CASE #PL2021-42

WALSER TOYOTA BLOOMINGTON, MN

Reviewed for Code Compliance
Date: 11/04/2022
By: K. Bayer
Plan # PRBD202210606

2022 NEW BUILDING FOR:
WALSER TOYOTA
4401 AMERICAN BLVD
BLOOMINGTON, MINNESOTA

FIRST FLOOR PLAN
12.21
1/8" = 1'-0"

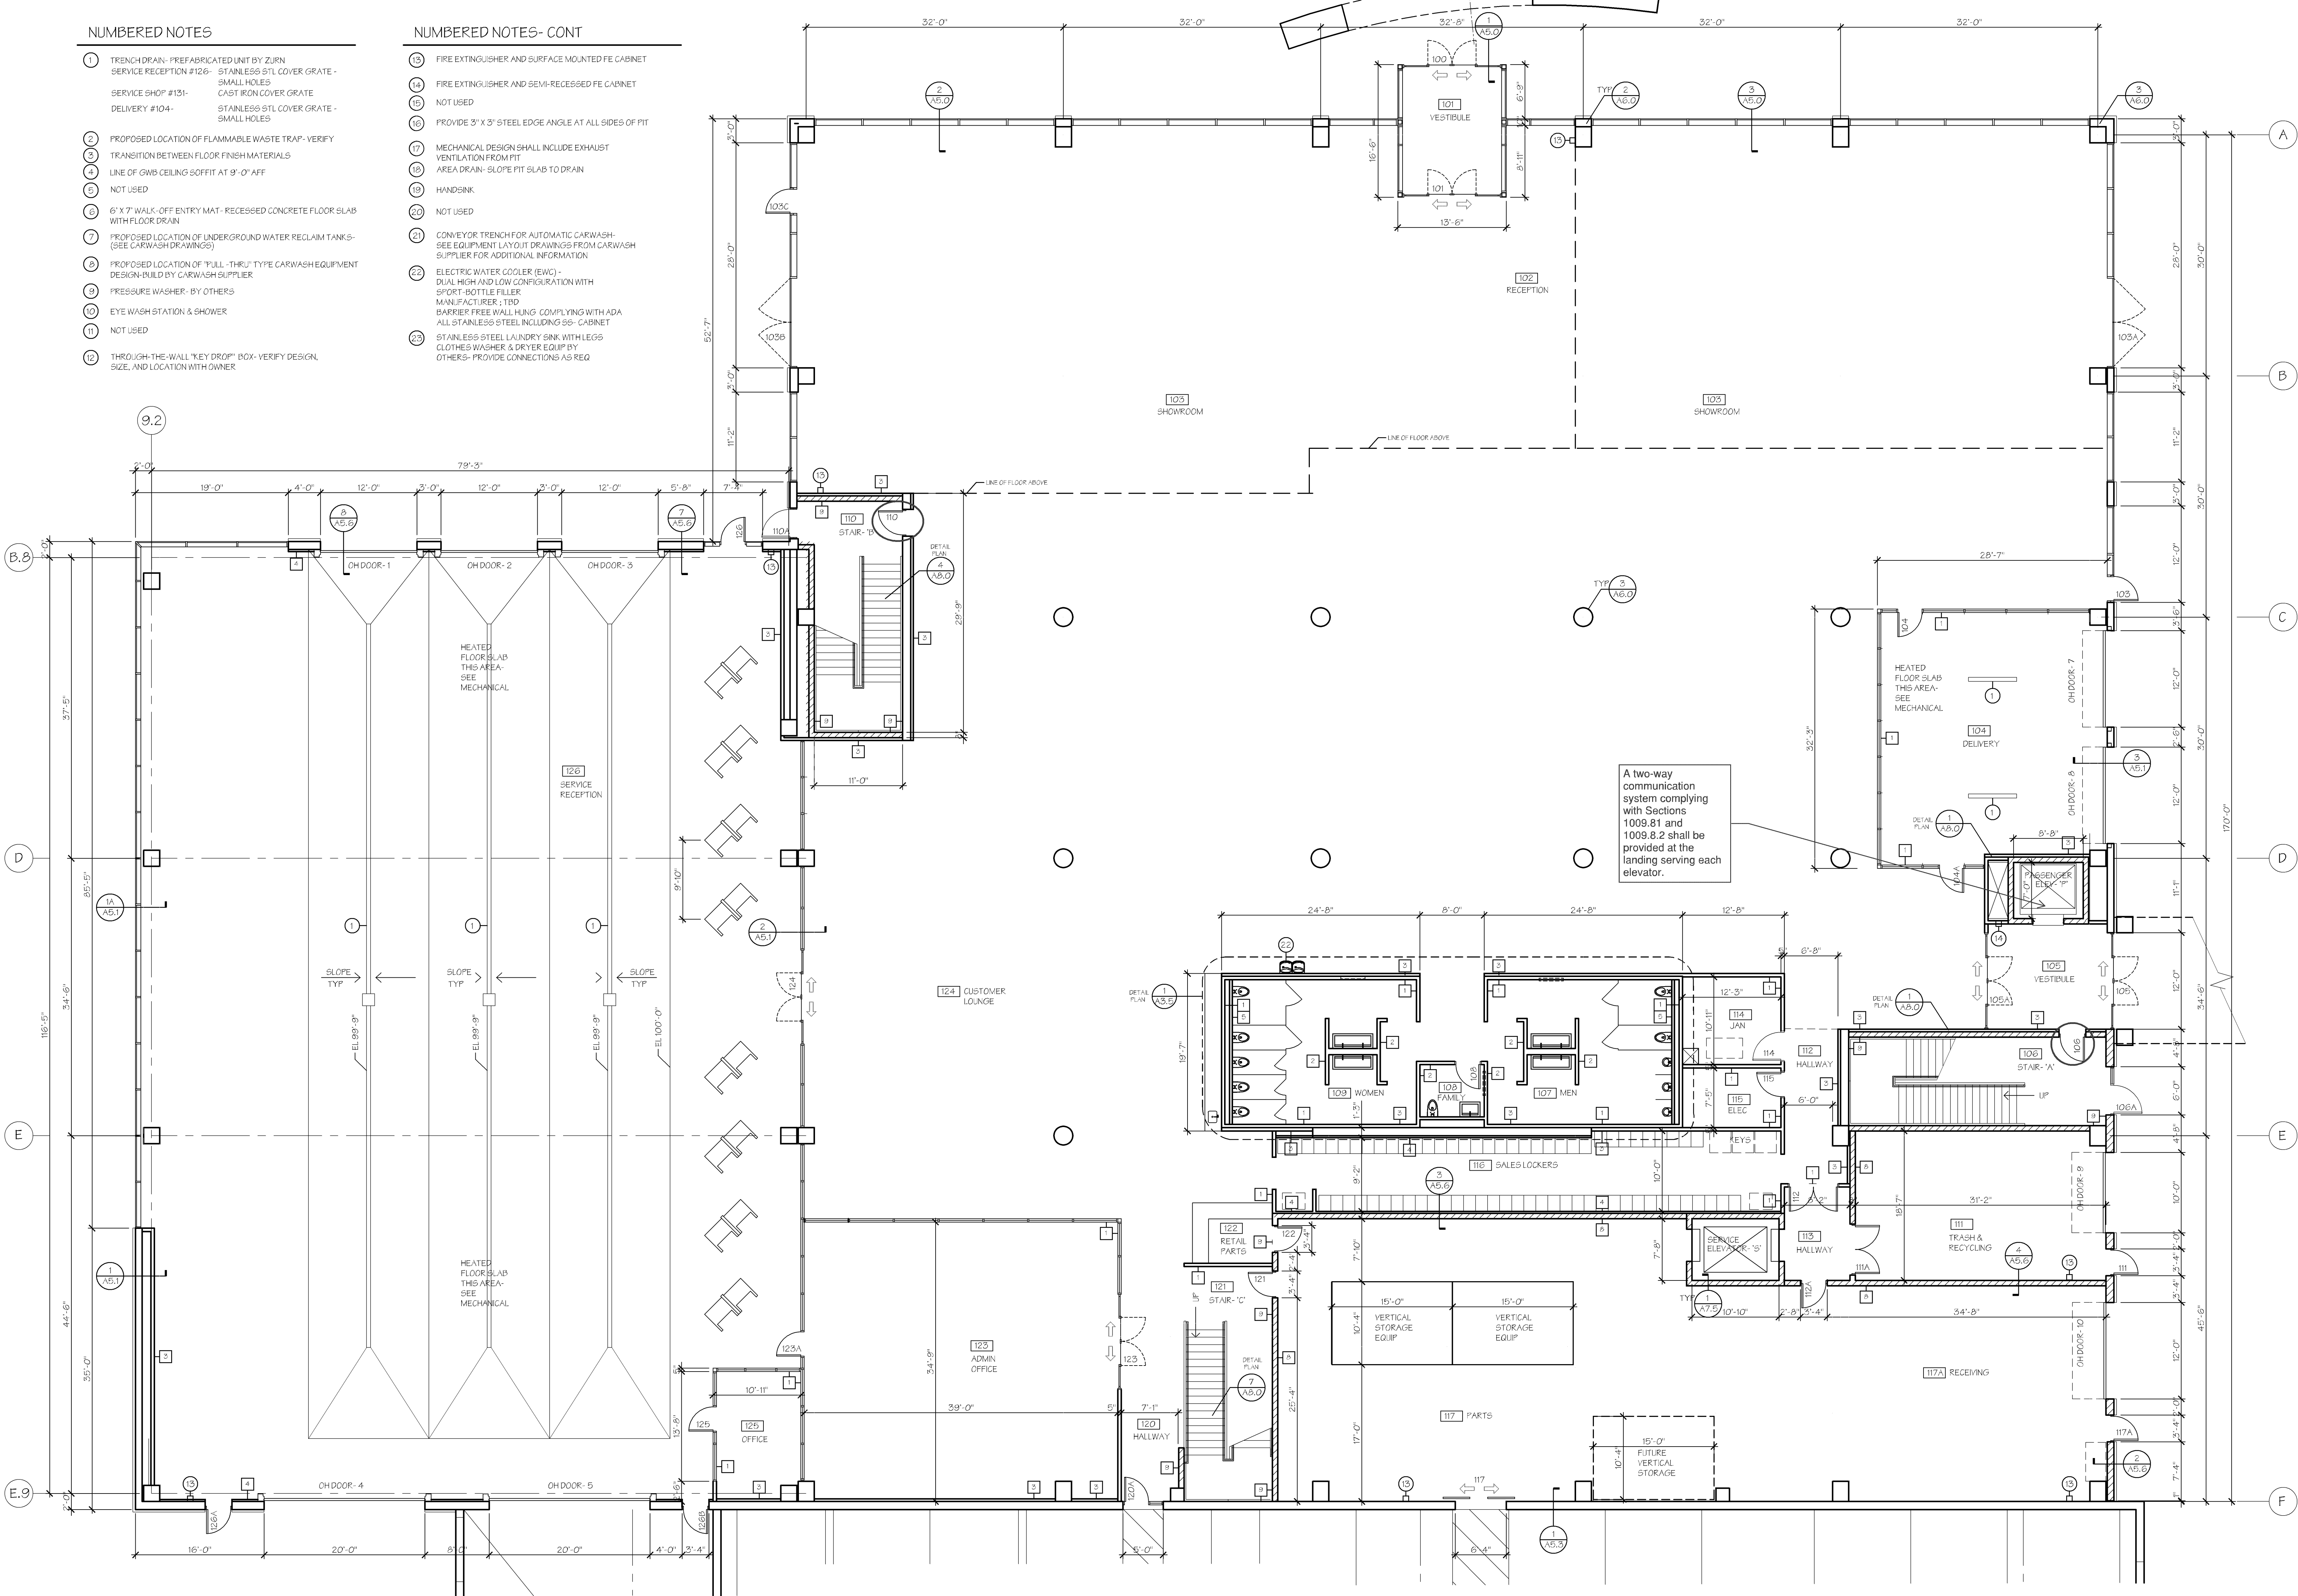
Fire and Life Safety System Requirements (Sprinklers, fire alarms, horns, strobes, etc) to be reviewed and approved by the Fire Marshal.

1 FIRST FLOOR PAN
12.02 1/8" = 1'-0" NORTH

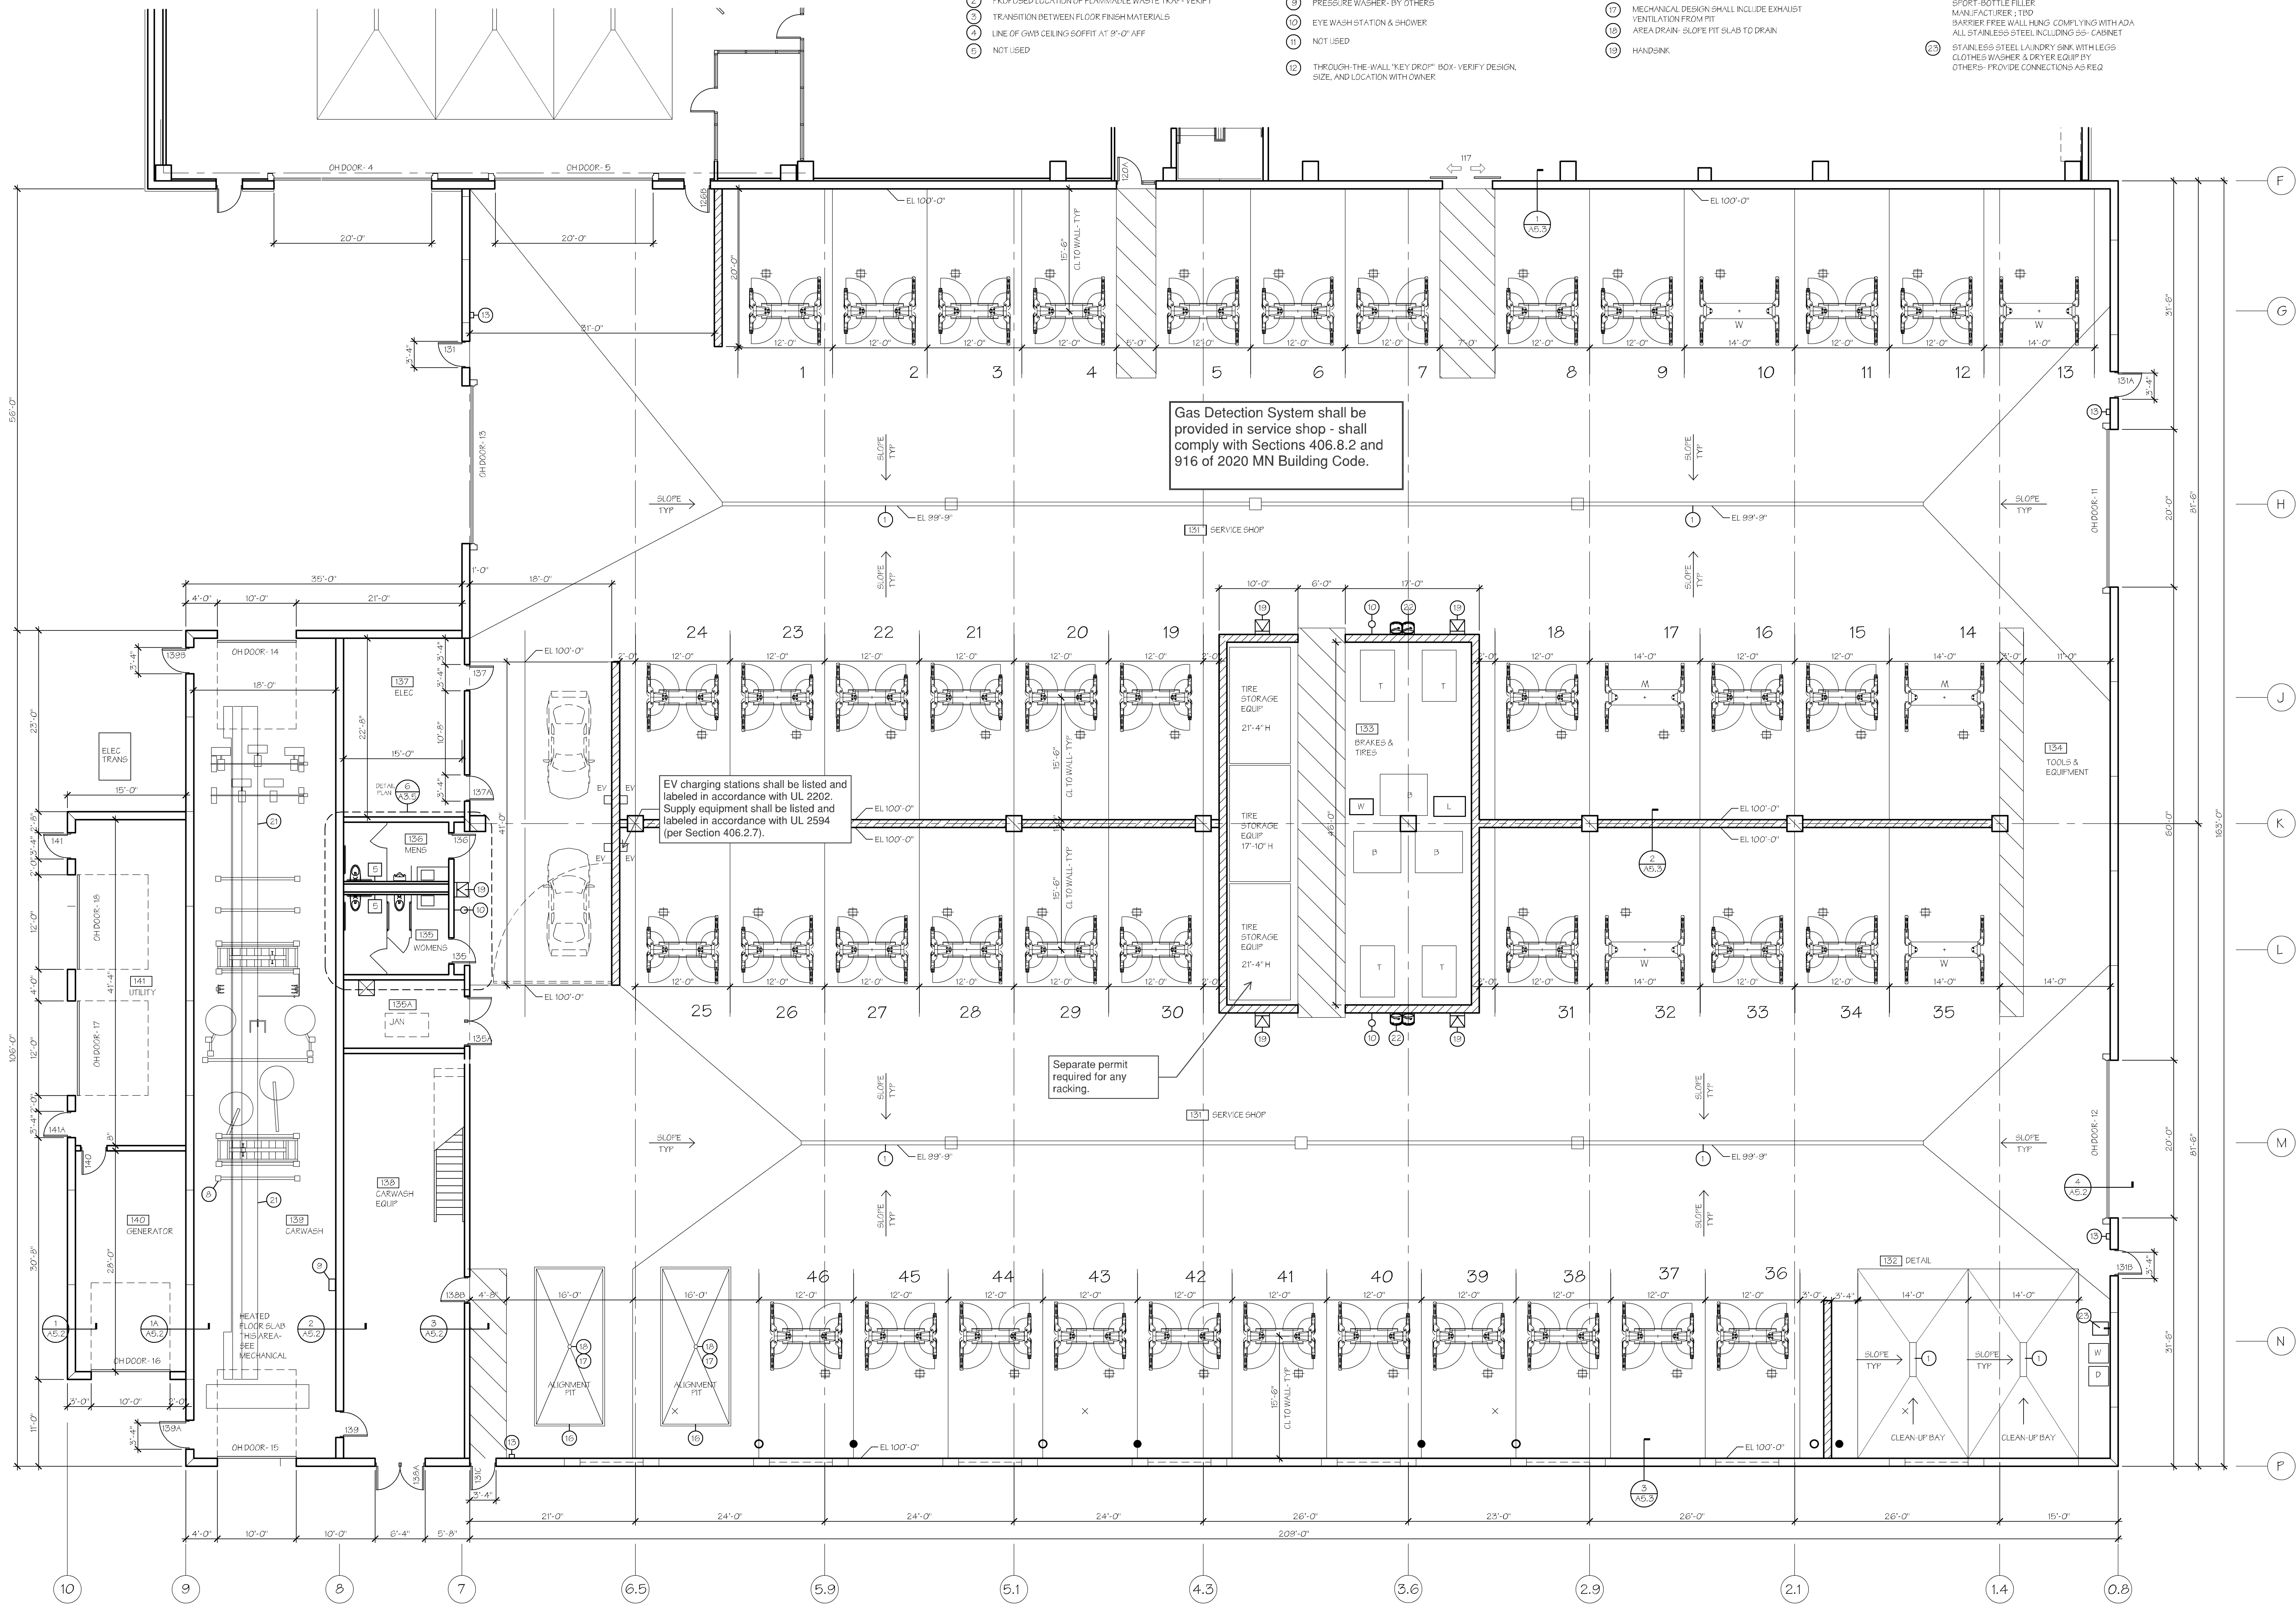
Gas Detection System shall be provided in service shop - shall comply with Sections 406.8.2 and 916 of 2020 MN Building Code.

EV charging stations shall be listed and labeled in accordance with UL 2202. Supply equipment shall be listed and labeled in accordance with UL 2594 (per Section 406.2.7).

Separate permit required for any racking.
